**MODIFICATION REQUEST TO CONCEPT
APPROVAL AND STATE SIGNIFICANT
DEVELOPMENT ASSESSMENT REPORT:**

**Concept Approval MOD 10
SSD Application for Block 4N**

Central Park (former Carlton United Breweries site)

MP 06_0171 MOD 10 and SSD 6673

Figure 7: Comparison between the Concept Approval (left) and the proposed (right) building envelopes highlighting increases (pink/orange) and reductions (blue) (Source: applicant's application)

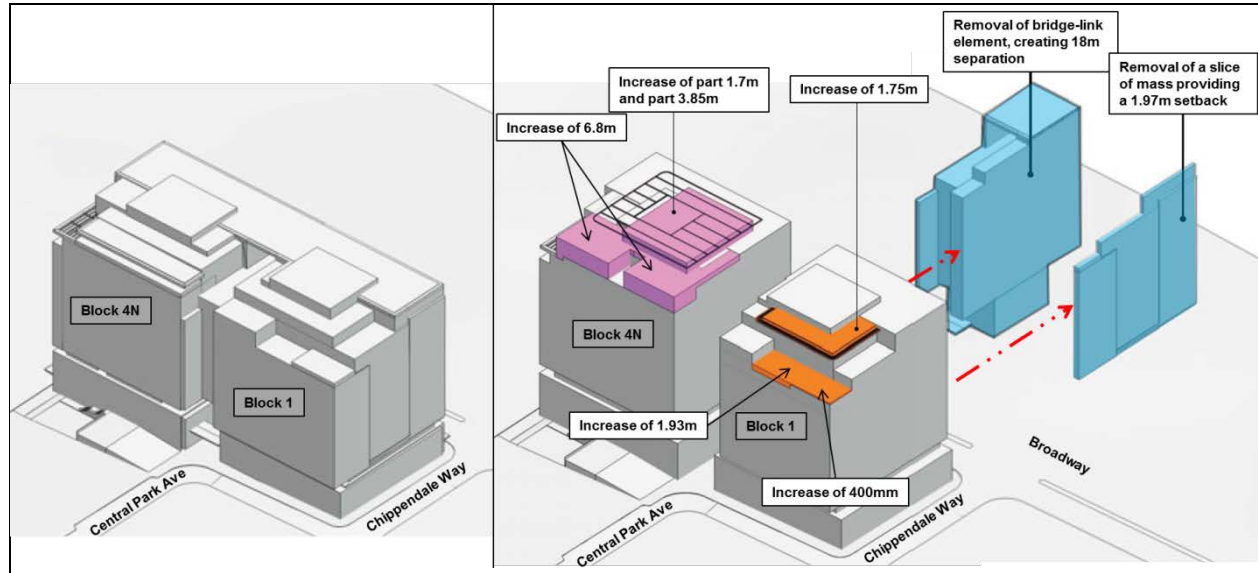
- the provision of a setback on the eastern elevation of Block 1 fronting Chippendale Way will provide for a minimum separation distance of 24 metres to the neighbouring residential building at Block 2;

- the increase in building height at Block 4N maintains the an appropriate transition to the neighbouring Blocks 4S to the south and Block 1 to the east and will provide for a building of appropriate stature at this prominent intersection / corner location;

- the increase in building envelope height to the rear of Block 1 is minor and would not result in a noticeable increase in bulk or scale when viewed from the surrounding streets or open space; and

- the shadow analysis submitted with the application has demonstrated that the revised building envelopes allow for improved solar access to the immediate surrounding public domain, compared to the approved envelopes.

Figure 8: The location of the proposed short term car parking (Base source: MP06_0171 MOD9 and applicant's RtS)

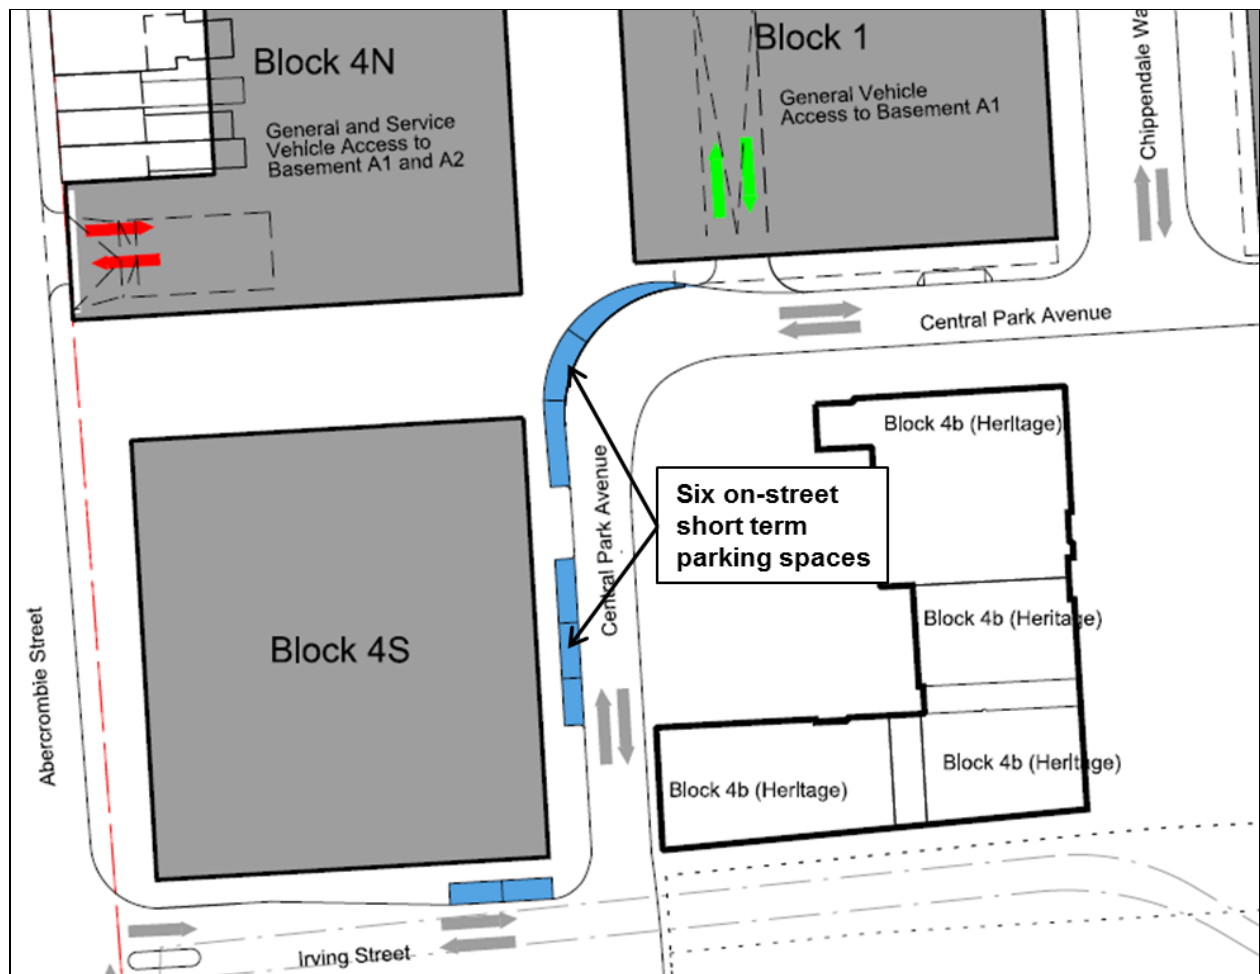
Council raised concerns with the number and location of the proposed additional car parking spaces. Specifically, Council stated that the number of spaces may be insufficient for the likely pick up / drop off requirements of the childcare facility and the hotel. Council also questioned the safety of the parking spaces situated on the curve of Central Park Avenue and ability of garbage trucks to manoeuvre around the bend of Central Park Avenue. Council also advised that adequate footway widths must be provided and the parking will need to be referred to the Local Pedestrian, Cycling and Traffic Calming Committee (LPCTCC).

The applicant has stated that the six proposed short term parking spaces are sufficient for the development as the client base for the childcare facility is likely to be local and within walking distance and also as the site is well served by public transport. The applicant submitted swept path analysis, which demonstrates that the pick up / drop off parking spaces located on the bend of Central Park Avenue can be used safely by cars and/or a small coach (a 7.9m long, 22 seater coach) and that garbage trucks can safely manoeuvre around the corner of Central Park Avenue when the short term parking spaces are in use (refer to **Figure 9**).

The Department notes that Council's Development Control Plan (DCP) 2012 recommends that childcare centres be provided with one pick up / drop off parking space per eight children, which equates to nine spaces for the proposal. However, the DCP outlines that the parking rate may be reduced having regard to the site's accessibility by walking and public transport. Council's DCP advocates a merit based assessment of coach parking requirements for hotel developments and does not specify a maximum or minimum coach parking rate.

Figure 12: Excerpt of level 11 indicating the separation between residential and hotel uses within Block 4N and separation of Block 4N and Block 1 (Base source: applicant's RtS)

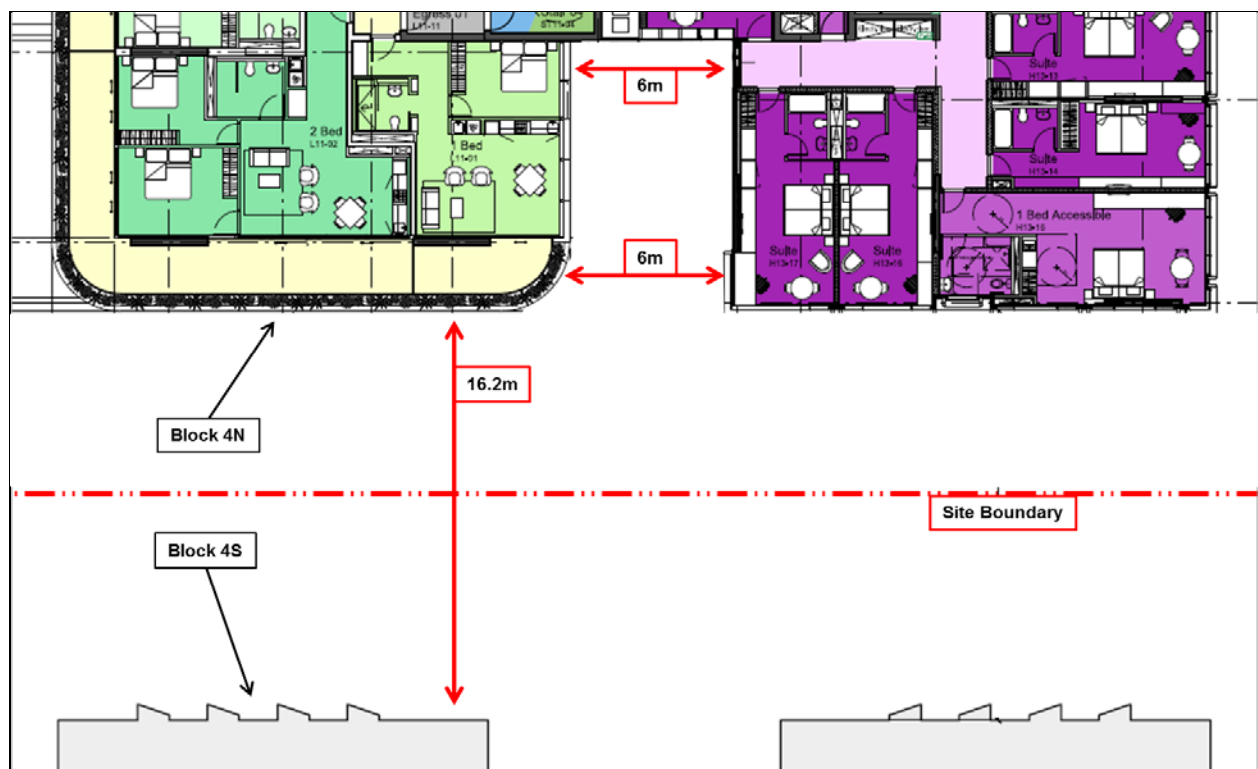
The six metre internal separation between the residential and hotel components is less than the 18 metres recommended by the RFDC and ADG. As a result of the limited separation, apartments on levels 11 to 16 may be affected by hotel suites and an internal corridor window directly opposite as shown at **Figure 12**. To ensure that the affected apartments are afforded an appropriate level of privacy, the Department recommends a condition that requires the hotel circulation corridor windows and hotel suite windows at each level be treated/screened.

Figure 13: Internal residential courtyard layout (left) and solar access (right) (Base source: Applicant's EIS and RtS)

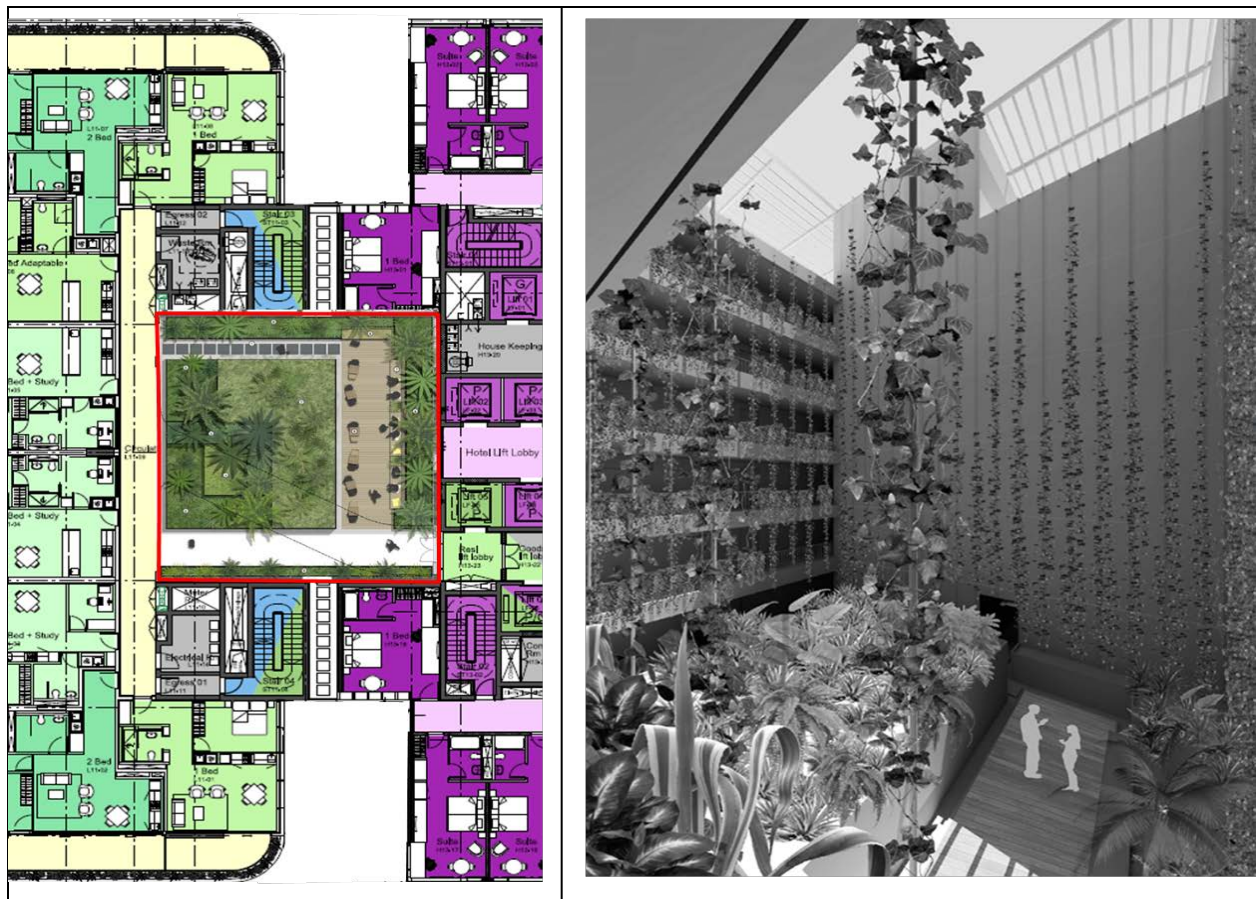
A total of 132m² residential communal open space is provided, in the form of an internal residential courtyard, at residential level 11. This equates to approximately 3.2% of the overall site area or 6.4% of the western portion of the site where the residential component is situated (refer to **Figure 13**).

The Department notes that the ADG states that variations to the percentage of communal open space are possible for sites with high site coverage or in a centre on the basis of increased private open space / balconies and/or good access to public open space and/or contributions to public open space.

While the overall amount of communal open space is less than recommended, Block 4N is near to Chippendale Green, which is a 6,000m² park provided by the applicant as part of the Concept Approval, and available for the use of residents, employees and the local community. In addition, apartments are provided with private open space in accordance with the objectives of the RFDC / ADC with a minimum depth of 2 metres. Given the context of the site and its closeness to Chippendale Green, the private open space provided to residents is acceptable.
